Proposed Technical Specification Change

Watts Bar Nuclear Plant Unit 1

Docket No. 50-390

Spent Fuel Pool Modifications
for Increased Storage Capacity

FIGURE 4.3-1
SPENT FUEL STORAGE RACKS

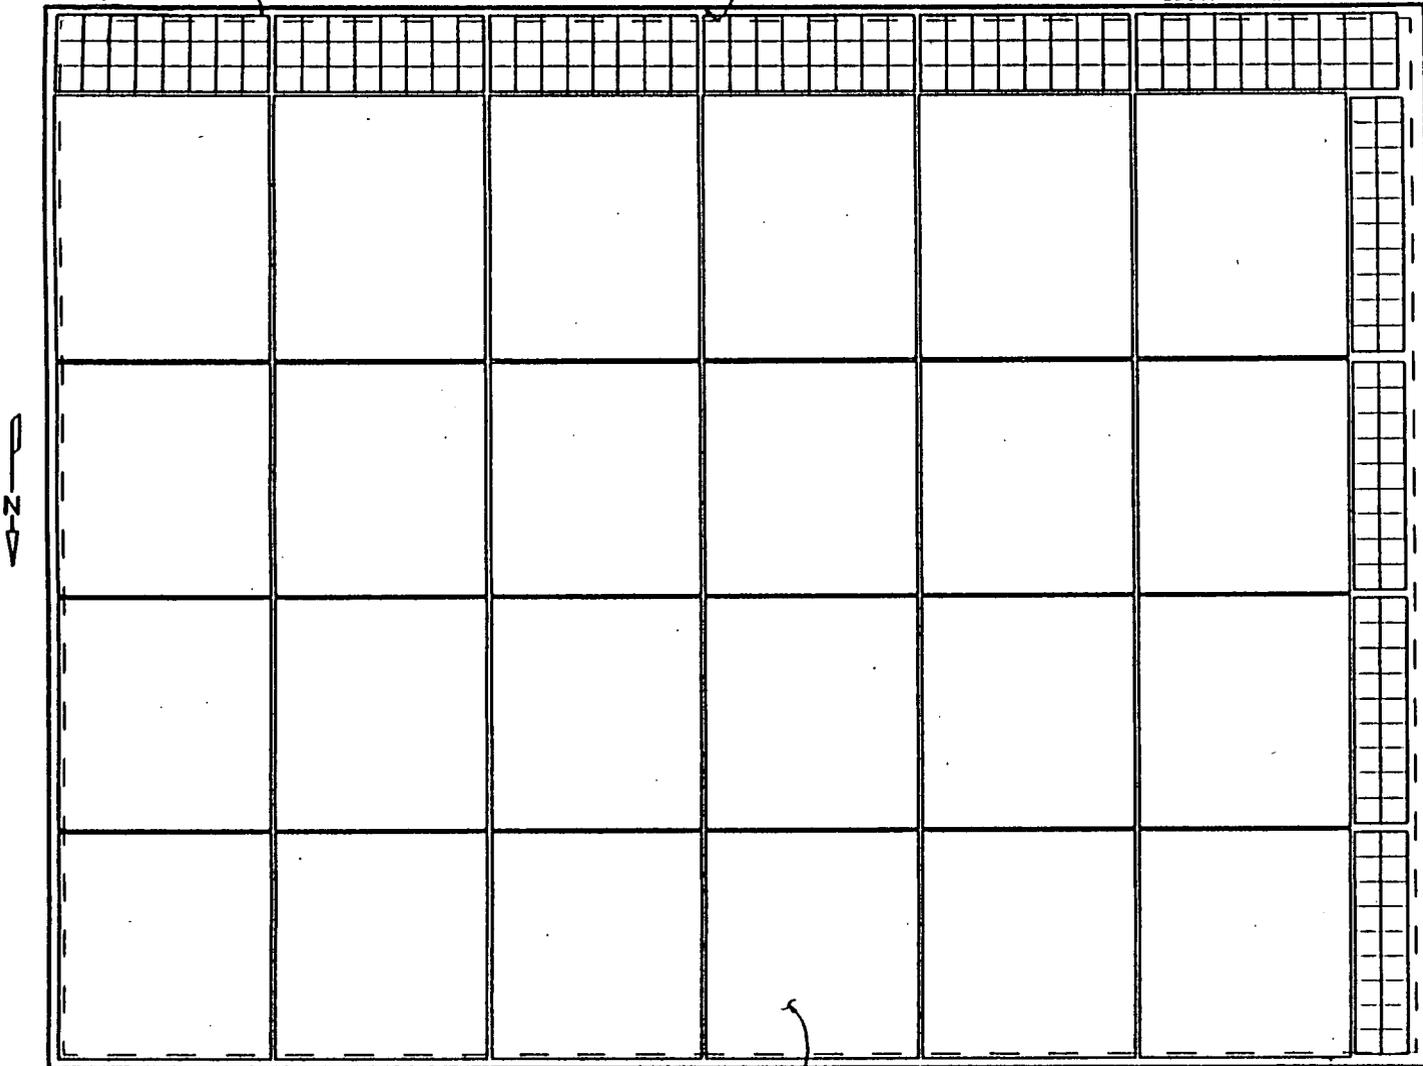
4.3.1.1 The spent fuel storage racks (shown in Figure 4.3-1) are designed and shall be maintained with:

- 4.3.3.1 The primary portion of the spent fuel storage pool is designed and shall be maintained with a storage capacity limited to no more than 1386 fuel assemblies in 24 flux trap rack modules.
- 4.3.3.2 No more than 224 fuel assemblies will be stored in ten smaller burnup credit rack modules peripherally located adjacent to the south and west walls of the pool.
- 4.3.3.3 In addition, no more than 225 fuel assemblies will be stored in a single 15 x 15 burnup credit rack module in the cask loading area of the cask pit.

Figure 3.7.15-1 Acceptable Burnup Domain - Watts Bar Spent Fuel Storage Racks

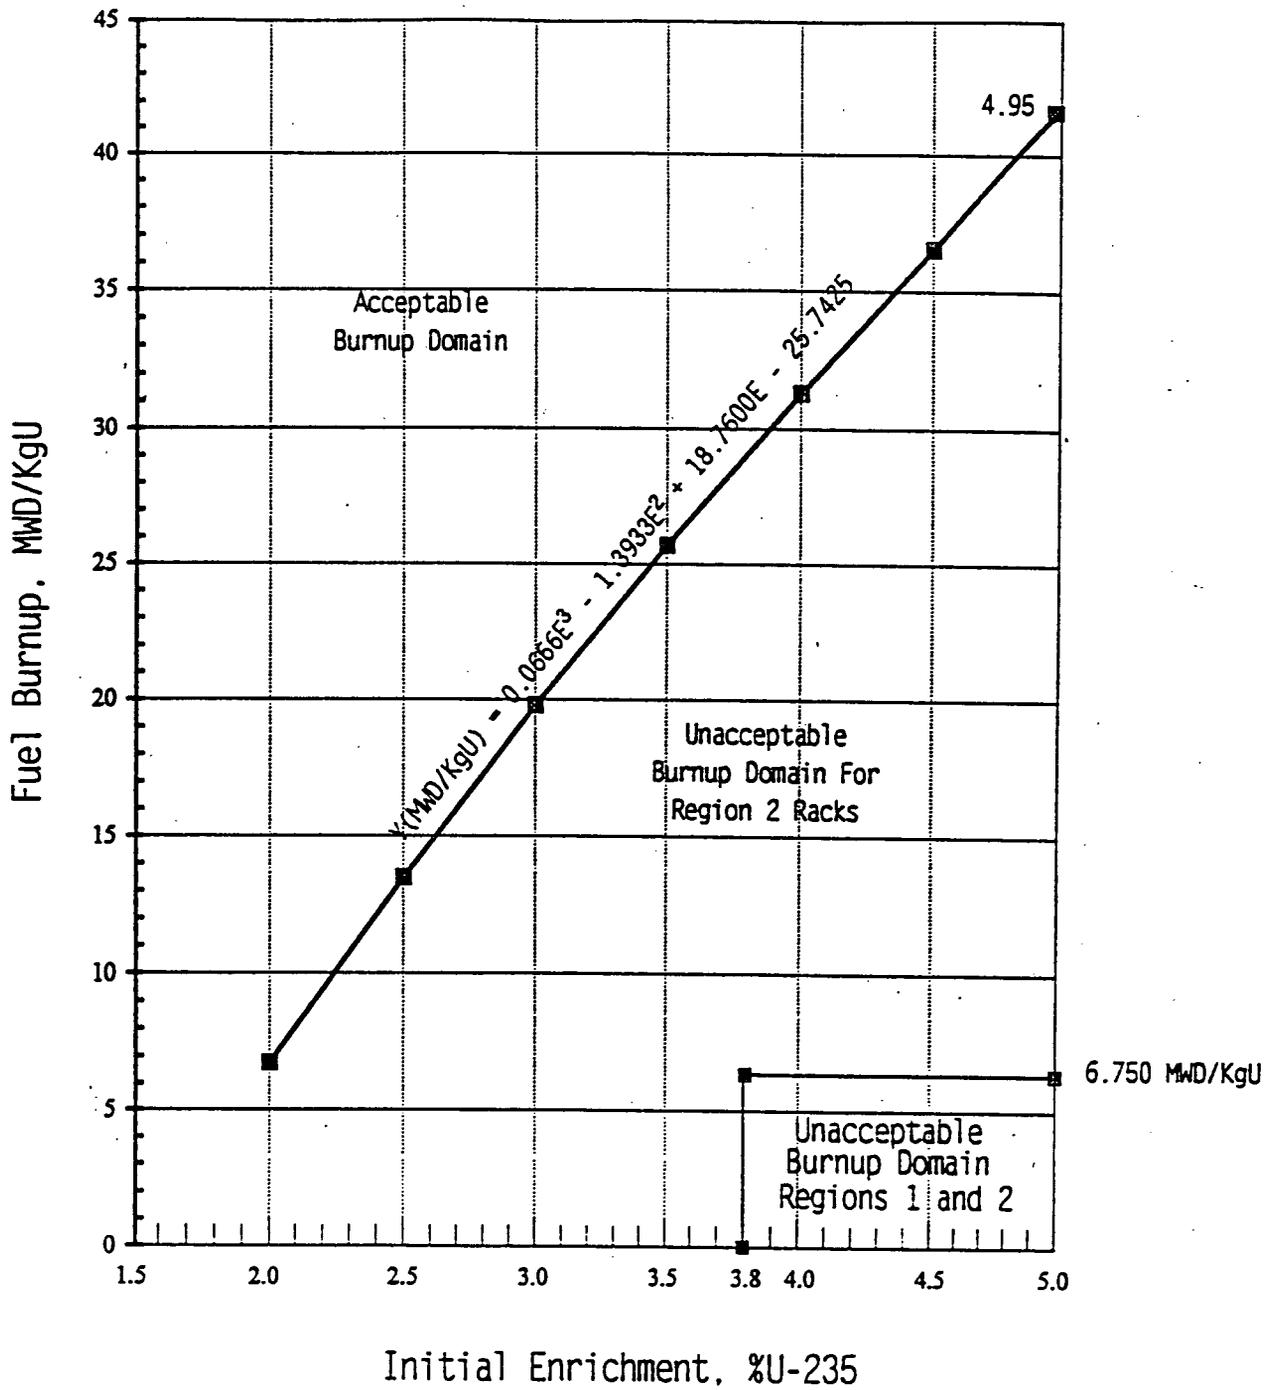
- d. Spent fuel assemblies with a burnup in the "acceptable burnup domain" of Figure 3.7.15-1 may be allowed unrestricted storage in either type of fuel storage rack.

- e. New or partially spent fuel assemblies with a burnup in the "unacceptable burnup domain" of Figure 3.7.15-1 will be stored in compliance with the following configuration:

2. Storage in any burnup credit rack modules (Region 2) located in the pool as well as in the fuel cask loading area is restricted to fuel of 4.95 ± 0.05 weight percent initial enrichment burned to at least 41 MWD/KgU (assembly average), or fuel of other enrichments with a burnup yielding an equivalent reactivity in the fuel racks. The minimum required assembly average burnup is given by $Y(\text{MWD/KgU})$ where $Y = 0.0666E^3 - 1.3933E^2 + 18.7600E - 25.7425$, where E is the initial enrichment in the axial zone of highest enrichment. Figure 3.7.15-1 illustrates the burnup enrichment equation in graphical form.

LCO 3.7.15 The combination of initial enrichment and burnup of each spent fuel assembly stored in Region 1 or Region 2 shall be within the Acceptable Burnup Domain of Figure 3.7.15-1 or in accordance with Specification 4.3.1.1.

FIGURE 3.9-1 Relationship Between Load, Allowable Height and Impact Area for Dropped Object

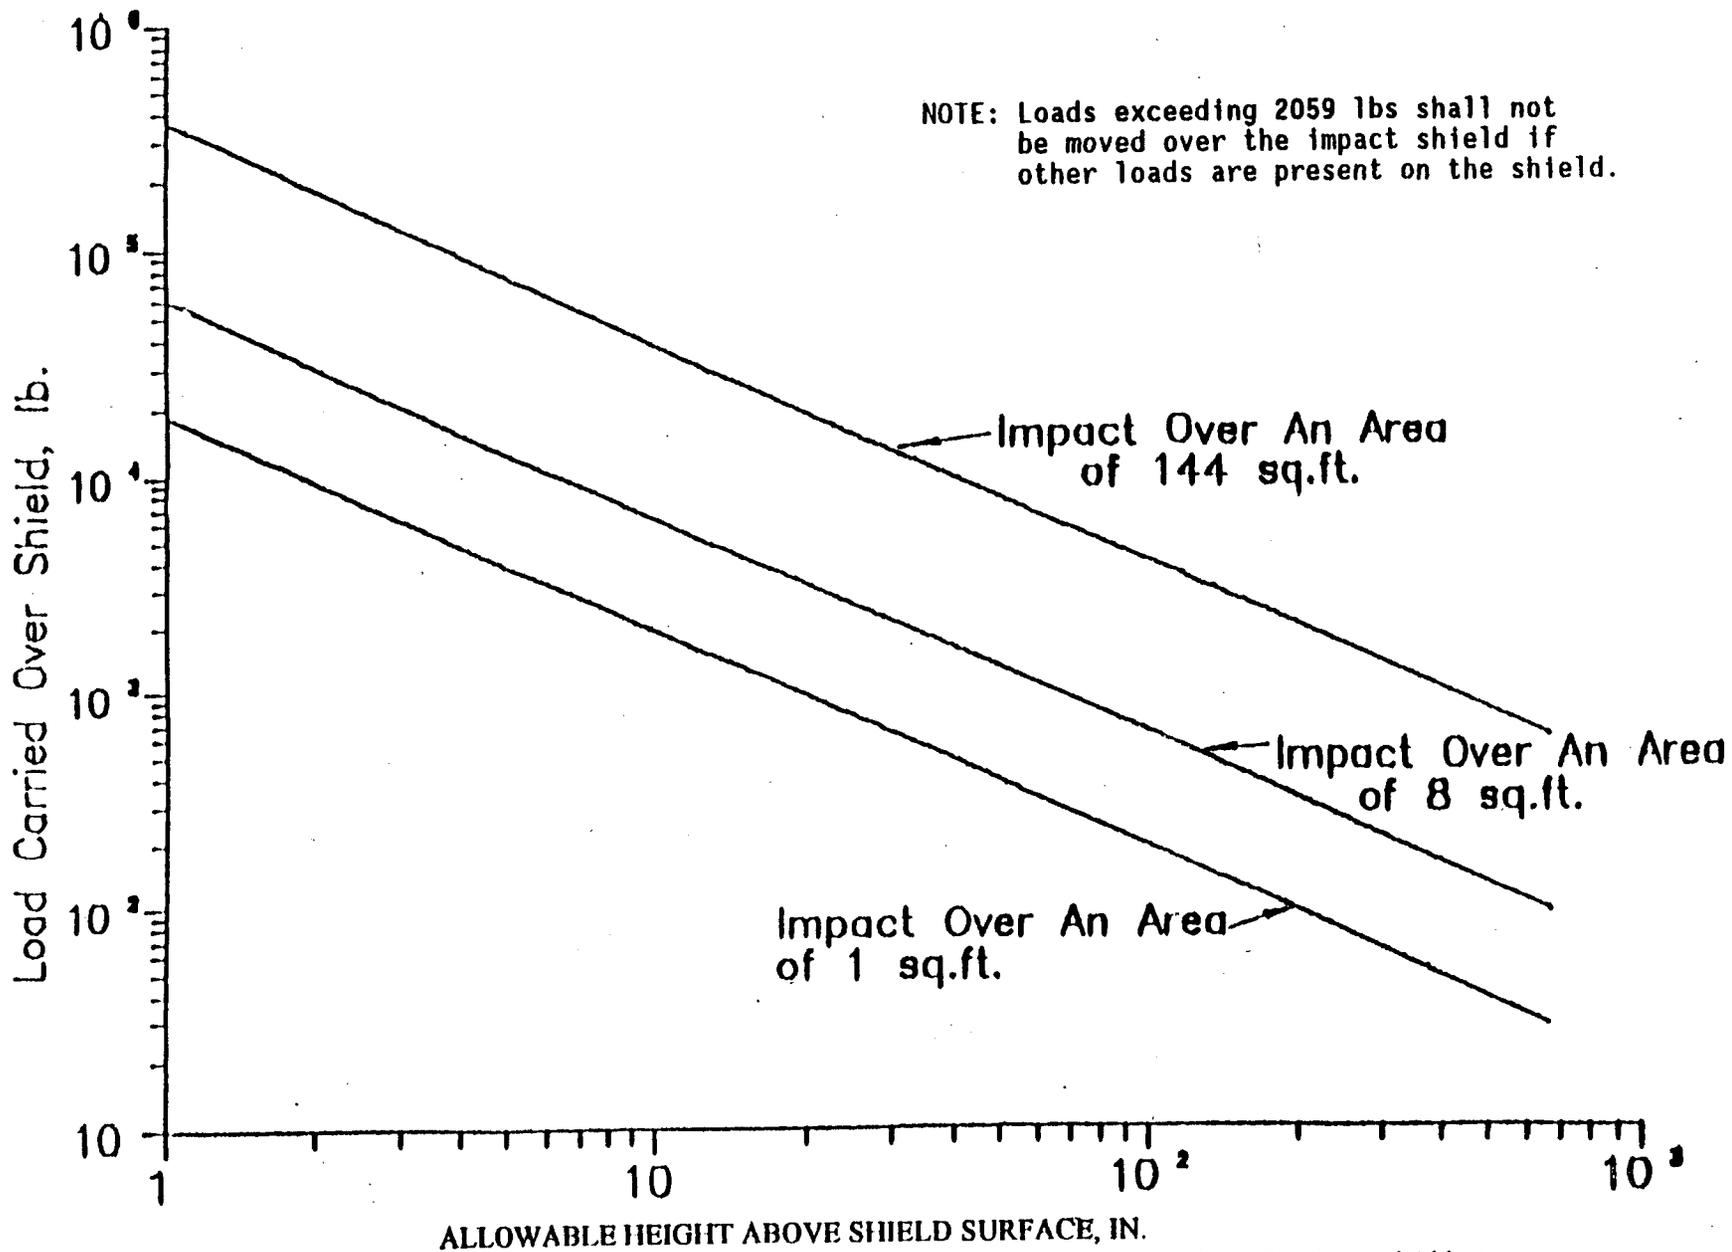
- 1. Loads which meet the weight, cross-sectional impact area, and allowable travel height criteria of Figure 3.9-1 may be carried over fuel assemblies stored in the cask loading area of the cask pit if the impact shield is in place over the cask loading area.
- 2. Loads which do not meet the weight, cross-sectional impact area, and allowable travel height criteria of Figure 3.9-1 shall be prohibited from travel over the cask loading area of the cask pit when fuel is stored in this area.

TSR 3.9.4.2 requires prior verification that the impact shield is properly in place and that each load exceeding 2059 lbs carried over fuel in the cask loading area of the cask pit meet the weight, cross-sectional impact area, and allowable travel height criteria shown in Figure 3.9-1.

NOTE: Loads exceeding 2059 lbs shall not be moved over the impact shield if other loads are present on the shield.

FIGURE 4.3-1
SPENT FUEL STORAGE RACKS

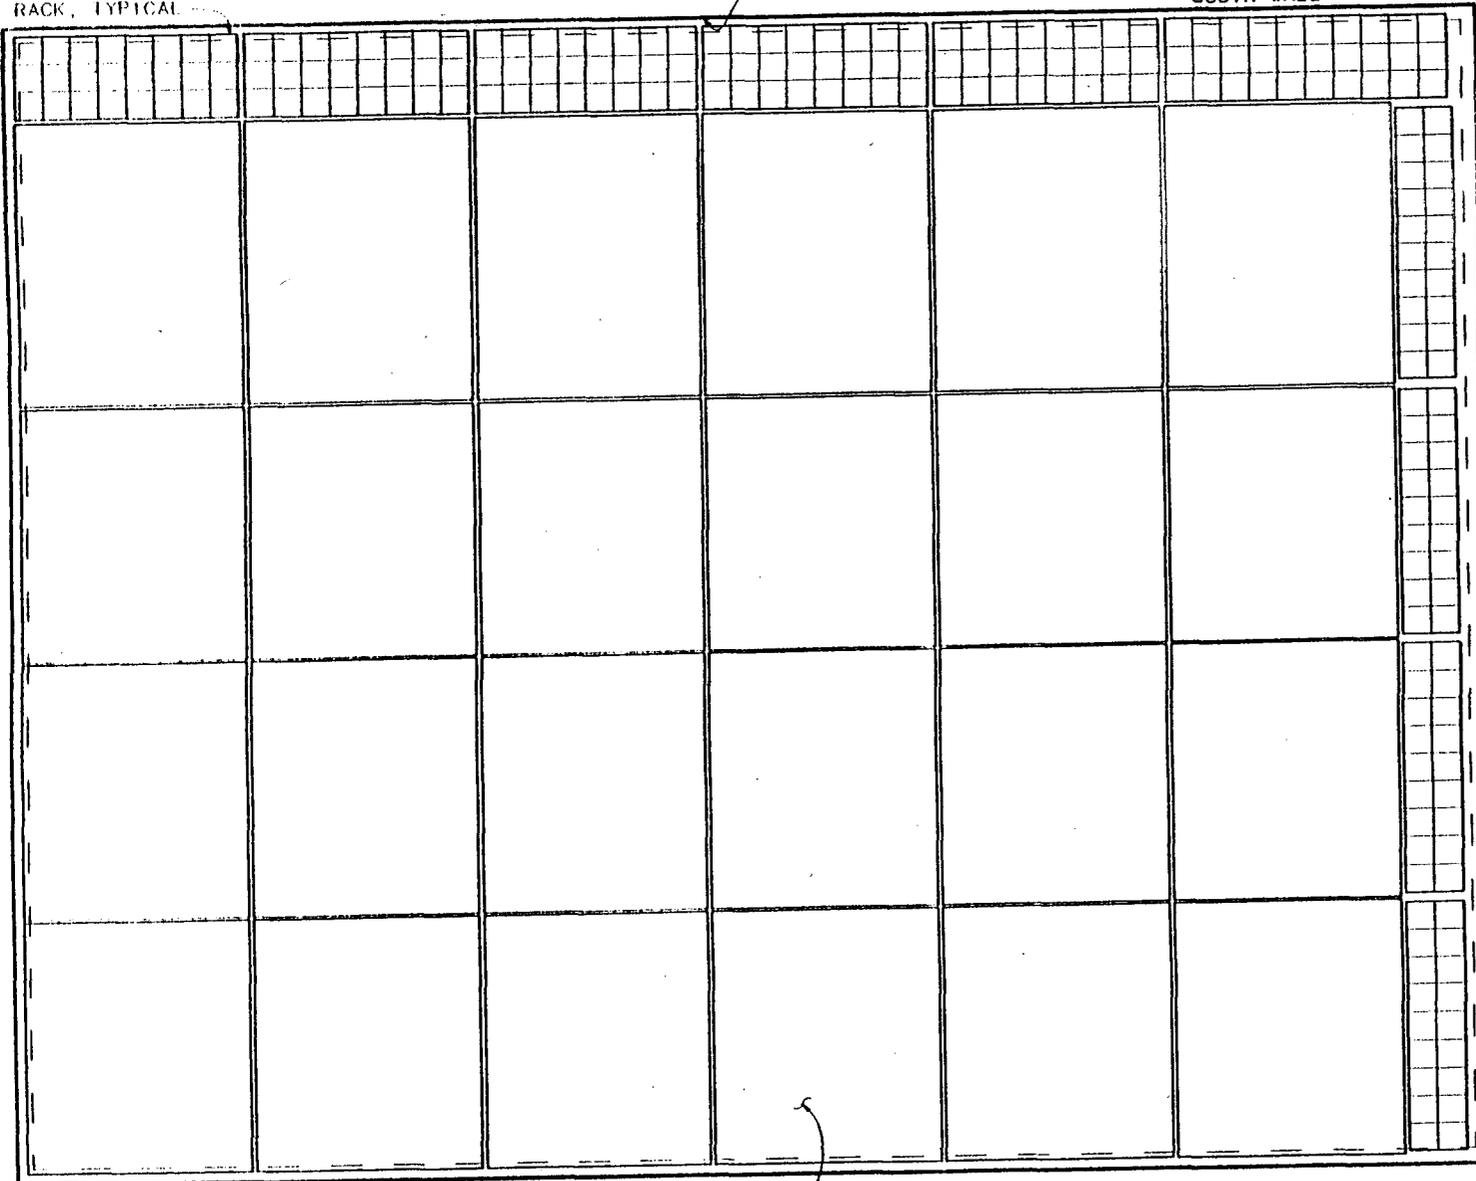
4.3.3.1 The primary portion of the spent fuel storage pool is designed and shall be maintained with a storage capacity limited to no more than 1386 fuel assemblies in twenty-four flux trap rack modules.

4.3.3.2 No more than 224 fuel assemblies will be stored in ten smaller burnup credit rack modules peripherally located adjacent to the south and west walls of the pool.

4.3.3.3 In addition, no more than 225 fuel assemblies will be stored in a single 15 x 15 burnup credit rack module in the cask loading area of the cask pit.

Figure 3.7.17-1 (page 1 of 1)
Fuel Assembly Burnup Limits in Region 2

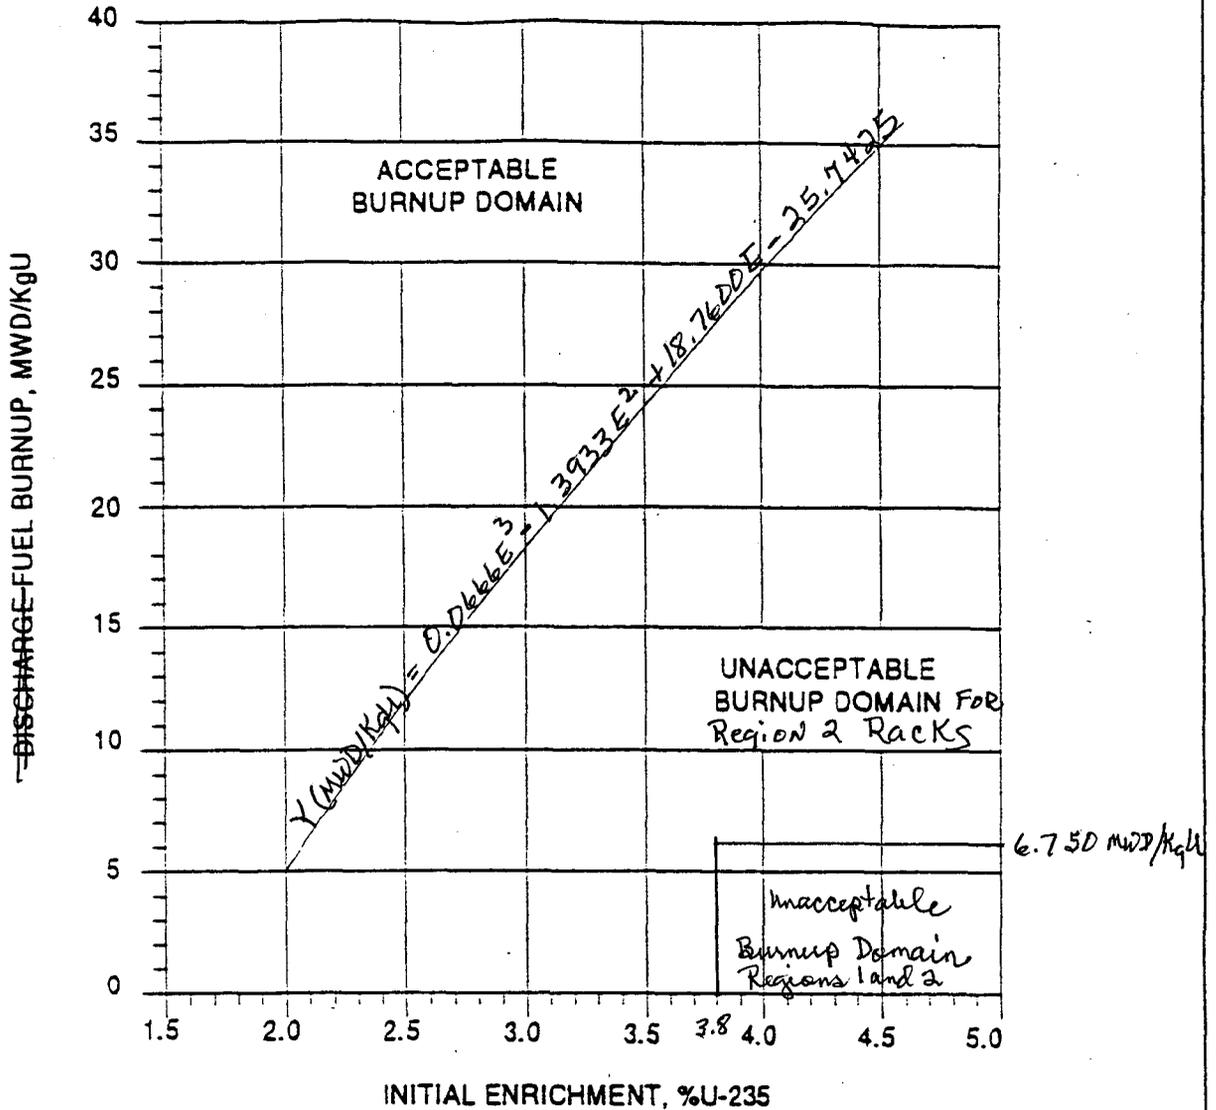
LCO 3.7.17¹⁵ The combination of initial enrichment and burnup of each spent fuel assembly stored in ~~[Region 2]~~ shall be within the Acceptable ~~{Burnup Domain}~~ of Figure 3.7.17-1 or in accordance with Specification 4.3.1.1. 15

The restrictions on the placement of fuel assemblies within the spent fuel pool, in accordance with Figure 3.7.17-1, in the accompanying LCO, ensures the ~~k_{eff}~~ ^{k_{eff}} of the ~~spent fuel storage pool~~ will always remain < 0.95, assuming the pool to be flooded with unborated water. Fuel assemblies not meeting the criteria of Figure [3.7.17-1] shall be stored in accordance with Specification 4.3.1.1 in Section 4.3.

When the configuration of fuel assemblies stored in ~~[Region 2]~~ the spent fuel storage pool is not in accordance with Figure 3.7.17-1, or paragraph 4.3.1.1, the immediate action is to initiate action to make the necessary fuel assembly movement(s) to bring the configuration into compliance with Figure 3.7.17-1 or Specification 4.3.1.1.
